**TOWN OF TRUMBULL
REQUEST FOR PROPOSAL**

**STROBEL ROAD RECONSTRUCTION PROJECT
LOTCIP NO. L144-0002**

Addendum #1 Dated March 21, 2019

3/21/19	ADDENDUM #1
DATE	DESCRIPTION
ECT NO:	T0196
T0196-15-C-510-LAYO.dwg	
WN BY:	MDS
CKED:	CRD
OVED:	AJM
CULVERT LAYOUT AND ELEVATION PLAN	
LE:	AS NOTED
C5.2

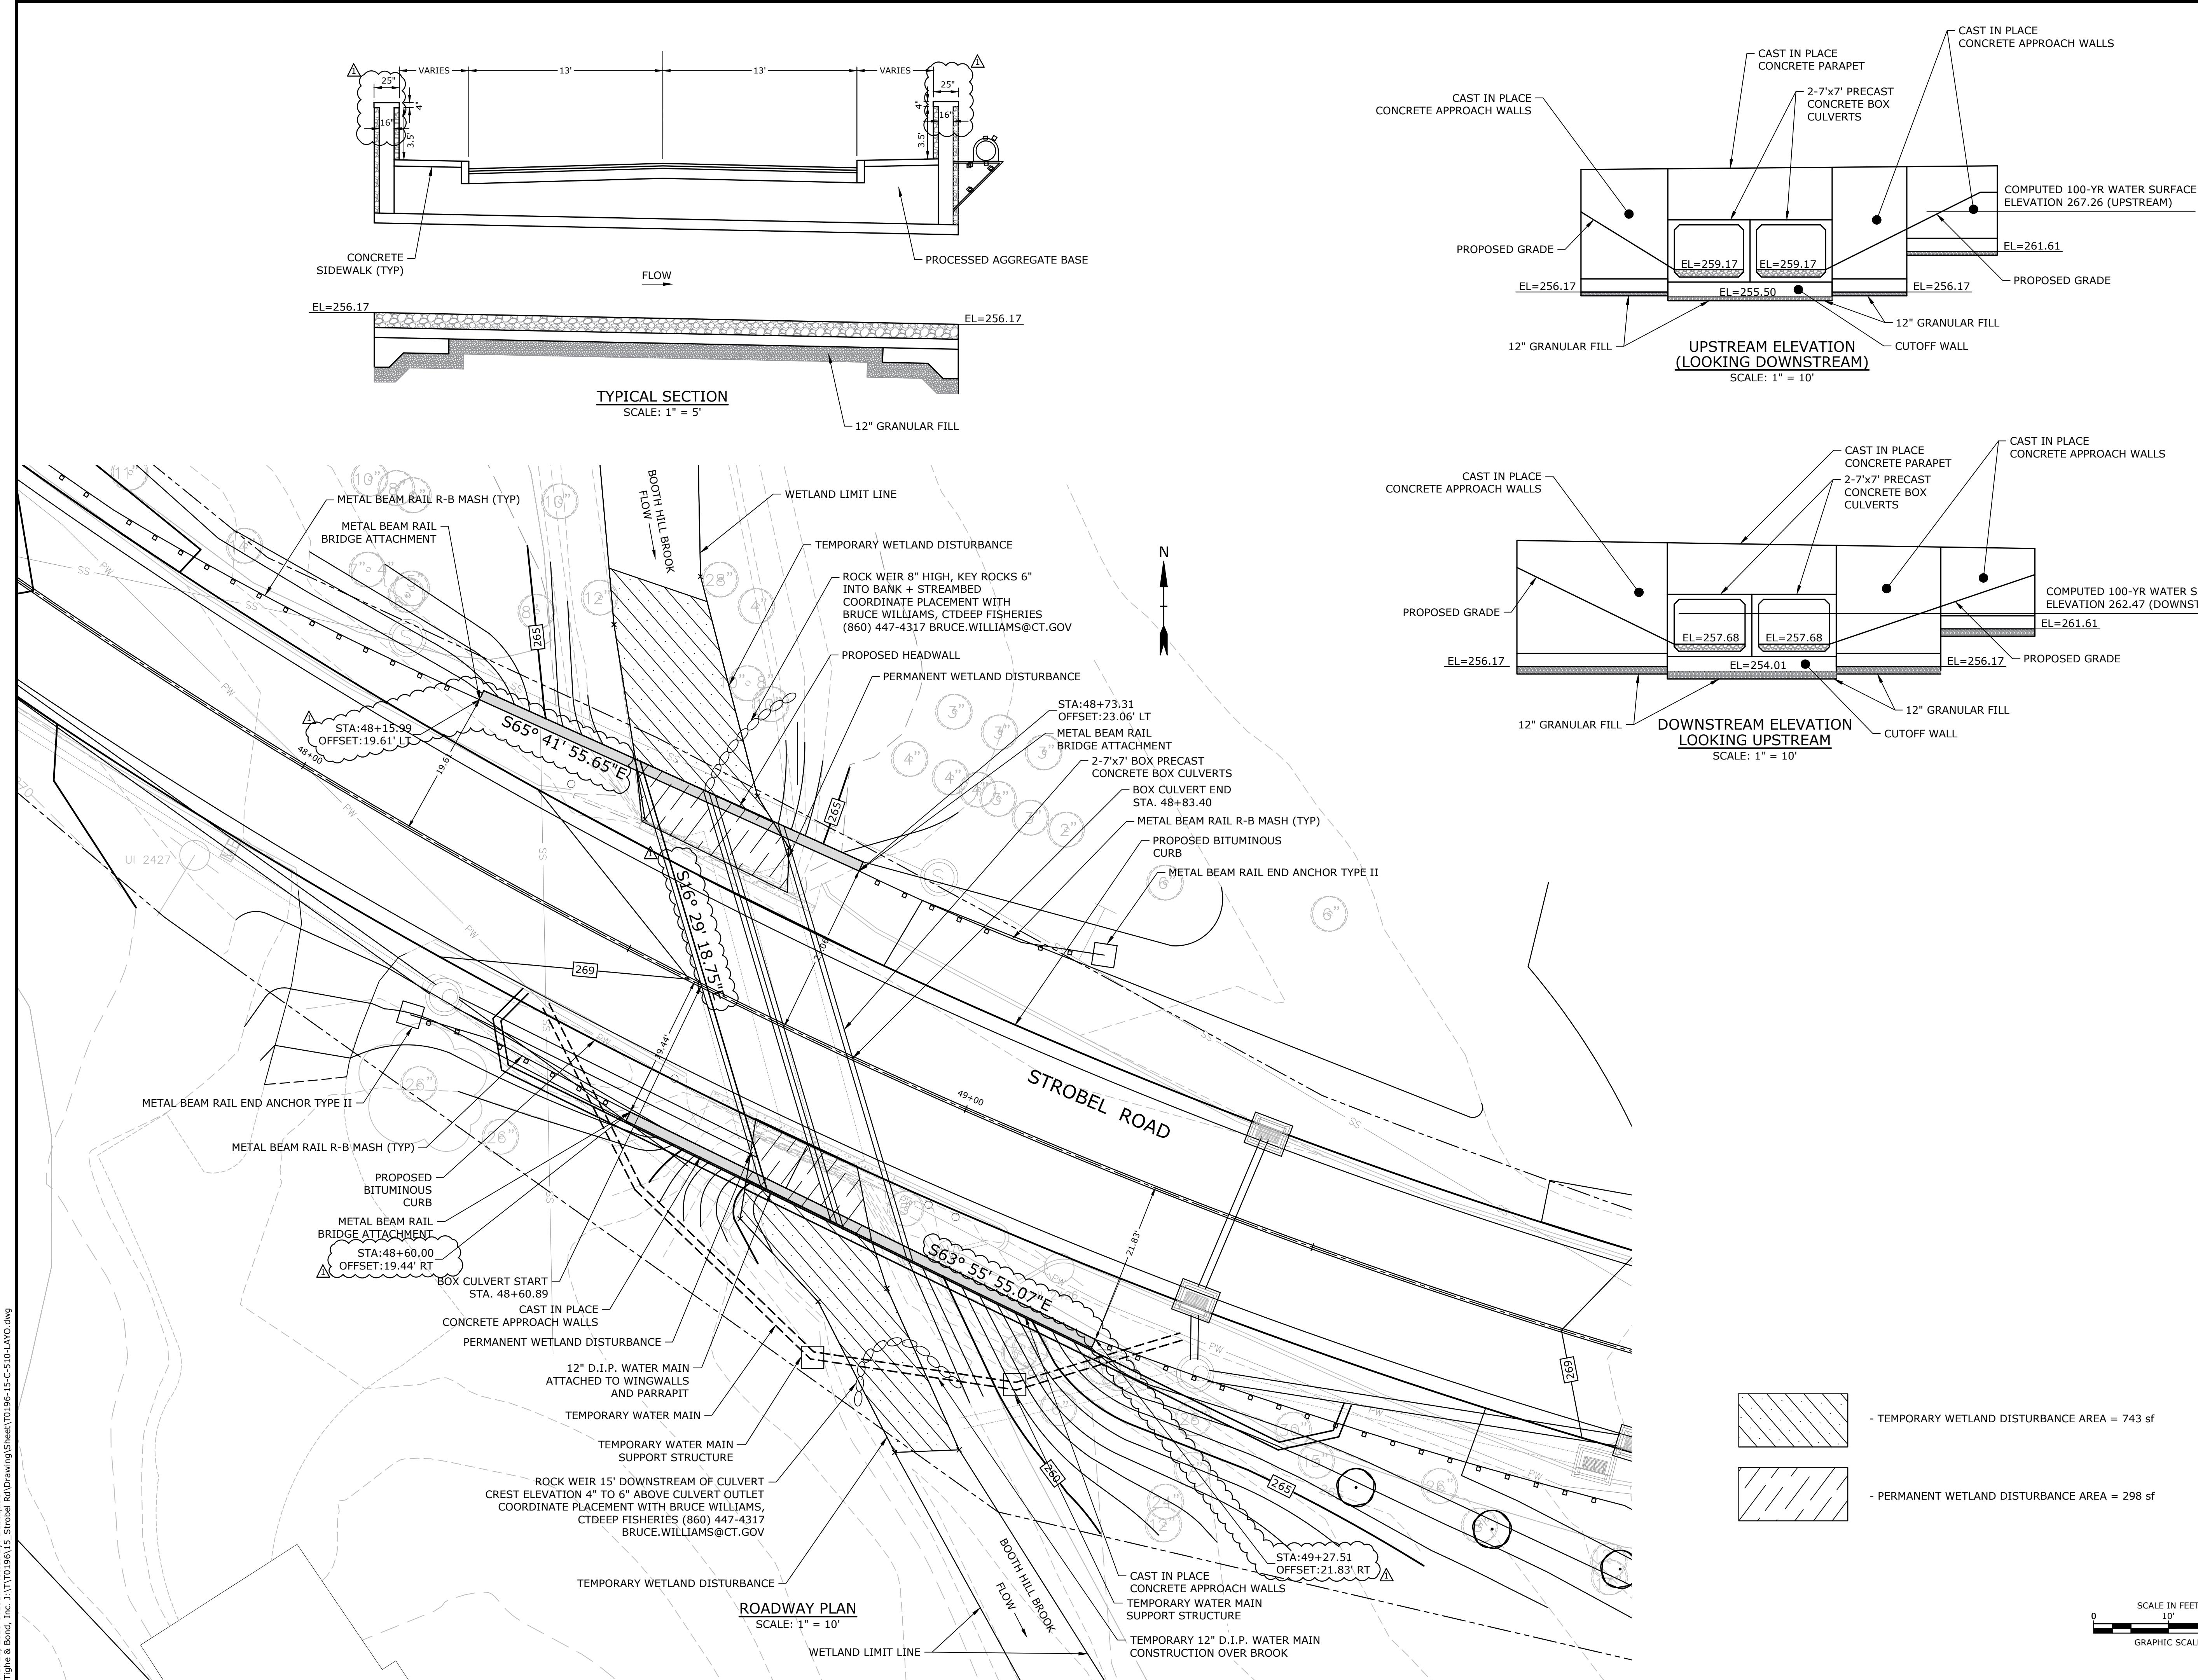
Question No. 1: Additional layout information is needed for the box culvert and wingwalls (working points, bearing, top of wall and parapet, wingwall layout/dimensions).

Response No. 1: Station and offset labels have been added at the end of the wing walls on the culvert layout plan (Sheet C5.2). The wall and culvert bearings have also been labeled on the plan. Dimension of the wingwalls and parapet have been corrected to match the detail Sheet C5.5.

The top of wingwall and parapet elevation varies and is 3'10" above the finished concrete sidewalk grade.
